Subject: MHI's Responses to US-APWR DCD RAI No. 585-4464 Revision 0

Reference: [1] "Request for Additional Information No. 585-4464 Revision 0, SRP Section: 09.02.01 – Station Service Water System - Design Certification and New License Applicants, Application Section: 9.2.1," dated May 10, 2010.

Responses to Request for Additional Information
No. 585-4464 Revision 0

RAI NO.: NO. 585-4464 REVISION 0
SRP SECTION: 9.2.1 – Station Service Water System
QUESTION FOR BALANCE OF PLANT BRANCH 2 (SBPB)

Figure 9.2.1-1 Essential Service Water System Piping and Instrumentation Diagram (Sheet 2 of 3)

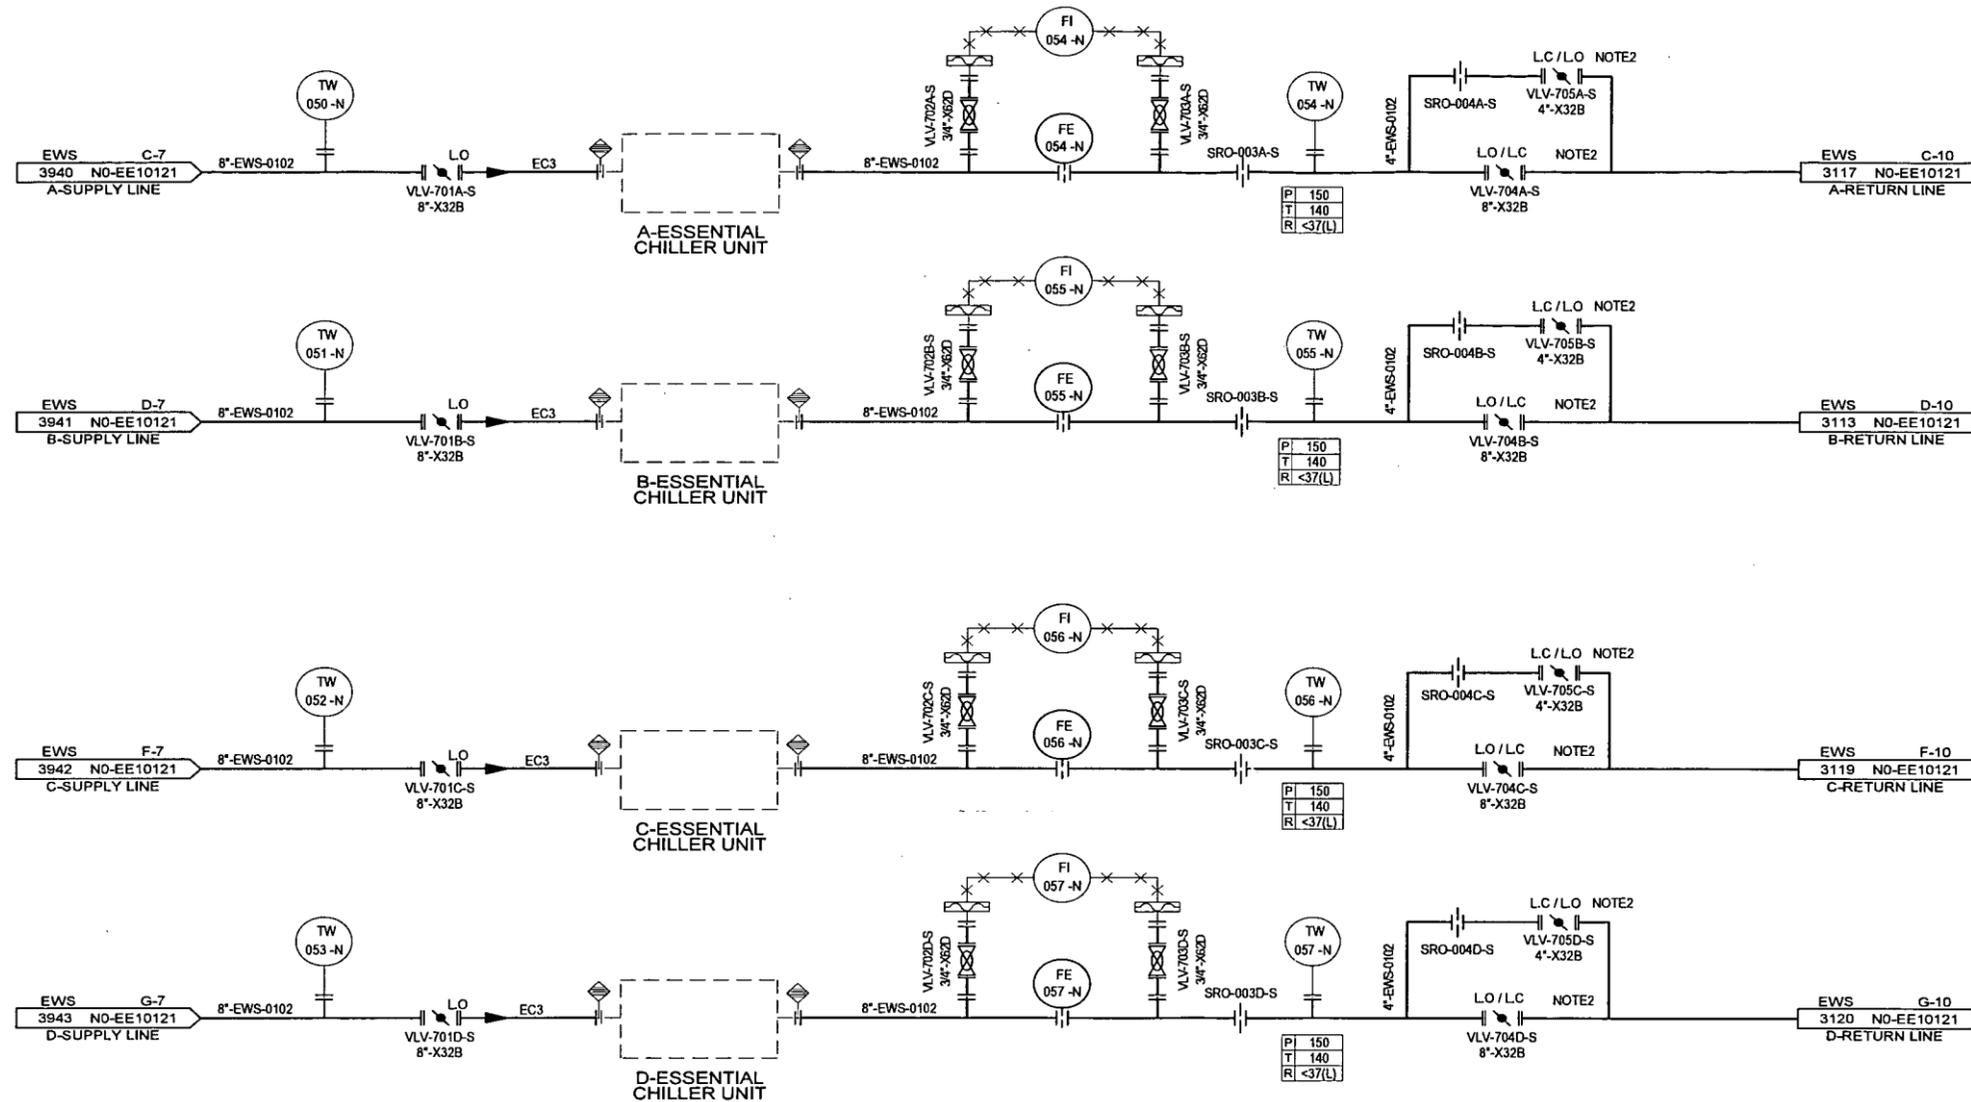
The system P&ID, Design Control Document (DCD) Figure 9.2.1-1, and description in Section 9.2.1 does not indicate vent lines or other means to provide for venting and filling the system. The system description also does not provide a description of operating procedures to fill and vent the ESWS or indicate this is a COL item. The system description in Tier 2 of the DCD Section 9.2.1 does not address the potential for water hammer, and system design to maintain functions following an inadvertent water hammer event. The Standard Review Plan (SRP) identifies NUREG-0927 "Evaluation of Water Hammer Occurrence in Nuclear Power Plants," that provides guidance for water hammer prevention and mitigation. In RAI 09.02.01-12, the applicant was requested to describe in the design control document (DCD) those design features to maintain design functions after an occurrence of water hammer and address procedures and commitments for venting and filling of systems to address the potential for water hammer, to maintain operating procedures for avoiding a water hammer event, and a system design to maintain functions following an inadvertent water hammer event.

Measures must be specified to protect the essential service water system (ESWS) from failures due to adverse environmental conditions. Tier 2, Design Control Document (DCD) Figure 9.2.1-1 indicates a strainer downstream of the two parallel strainers at the inlet to each component cooling water (CCW) heat exchanger in each train of the ESWS. The ESWS also provides cooling water flow to the essential chiller units; however, there is no such additional strainer indicated for the piping to the essential chiller units in each train. The staff asks the applicant to address, in the design control document, the need for an additional strainer for the essential chiller units served by the ESWS, either adding a necessary strainer or discussing the basis for why a strainer is not needed.

Measures must be specified to protect the essential service water system (ESWS) from failures due to adverse environmental conditions. The staff did not find, for the ESWS on Tier 2, Design Control Document (DCD) Figure 9.2.1-1 connections for backwash cleaning of the essential chiller units on the ESWS side. There is also no discussion of the need to backwash or clean the ESWS side of the essential chiller units and how this is accomplished. In RAI 09.02.01-20, the applicant was requested to describe in the DCD the need to backwash (clean) the ESWS side of the essential chiller units and provide indication of the connections and components on the Tier 2 Figure 9.2.1-1. In addition, clarify whether or not the associated ESWS train has to be removed from service for this operation.

Tier 2 DCD Figure 9.2.1-1 has been revised to include CDI.

The ESW header pressure instrumentation and the ESWP flow requirement are part of the standard design. The ESW header pressure instrumentation are labeled in DCD Figure 9.2.1-1 as PIA-015, PIA-016, PIA-017, and PIA-018. DCD Section 9.2.1.5.2 also provides a description of the ESW header pressure. All components, including piping and valves, shown in that drawing, unless otherwise stated, are part of the standard design. Components, including piping and valves, found in the DCD Figure 9.2.1-1 are part of the standard design unless otherwise noted.

All instrumentation available in the main control room are also provided locally. DCD Figure 9.2.1-1 has been appropriately revised.

See Attachment 1 for changes to Tier 2 DCD Figure 9.2.1-1.

Figure 2.7.3.1-1 Essential Service Water System

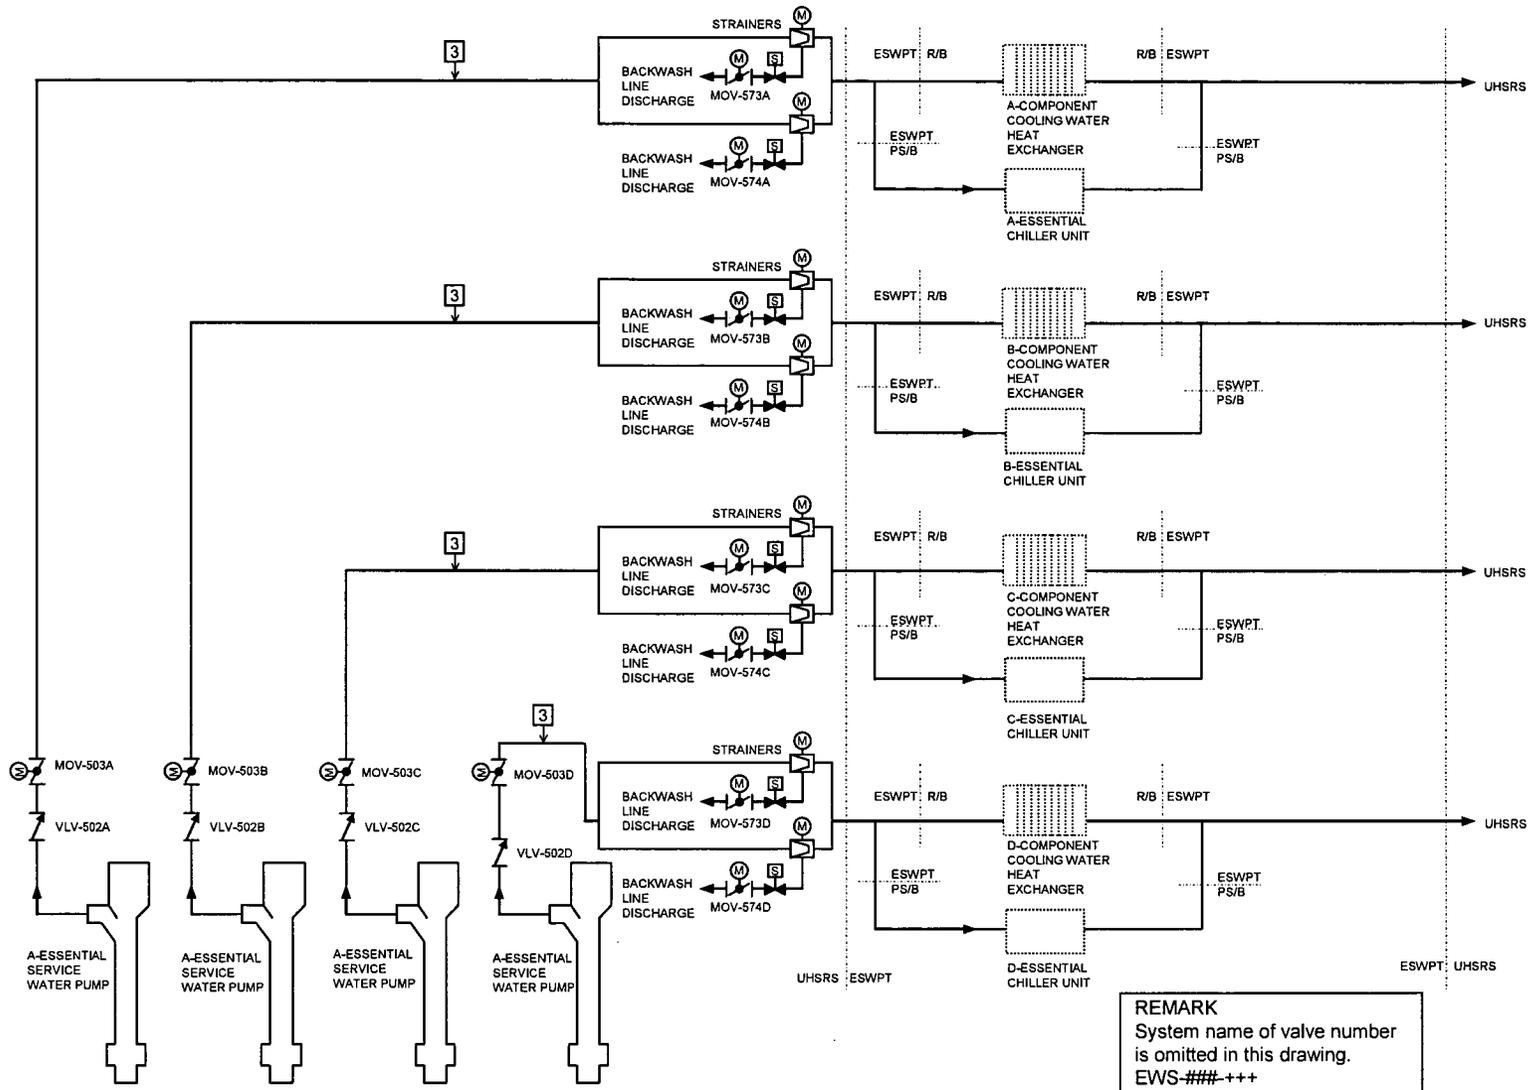
- b) The staff noted that Tier 1 of the DCD Figure 2.7.3.2-1 did not show many of the important system components, such as the radiation monitors, the strainers and piping for flushing the CCW strainers. A level of detail needs to be provided in the Tier 1 drawings of the DCD in order

to meet inspections, tests, analyses, and acceptance criteria (ITAAC) commitments for verifying system configuration. The applicant stated that a revised figure will be included containing the same level of detail. However, upon review of revision 2 of the DCD, the level of detail of Tier 1 drawings still appear to be inadequate, and Tier 1 Figure 2.7.3.2-1 appears to be an incorrect figure number. Therefore, this item will remain open pending a satisfactory response to this RAI issue by the applicant.

The ESWS automatic strainers with their backwash line, however, should be included in the Tier 1 Figure 2.7.3.1-1. Related Tier 1 Tables 2.7.3.1-1 through 2.7.3.1-4 have been revised to include the strainer information, including piping and valves. See following pages for the proposed markups to these tables.

The CCW heat exchanger inlet strainers have been removed from the design as mentioned in the response to Questions 09.02.01-34 and 09.02.01-52 so there is no need to include them in Figure 2.7.3.1-1.
